Re: 4th Avenue Well – Applicable Salt Lake Ordinance Requirements – Supplemental Points and Authorities concerning Master Plan and Historical Precedents - HLC PLNHLC2018-00557 and PLNHLC2018-00558

Proposed Fourth Avenue Well Drinking Water Chlorination Facility

Figure 2 - - Location of Brick Tank House at Elevation 4,598 feet per Hooton (1986).

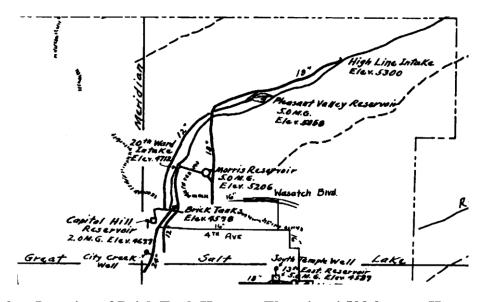
Historical Precedents: Analogous public water treatment facilities have been historically located in lower City Creek Canyon include a frame water settling tank at Pleasant Valley, a brick settling building with pumps, and a value switching station. These are illustrated in an 1898 Salt Lake Tribune article.⁴ Former DPU director Hooton's history of the City Creek water system⁵ indicates that the brick tanks were located near the 4,598 foot elevation (Figure 1)⁶ to the north and outside of the Memory Grove residential pocket.
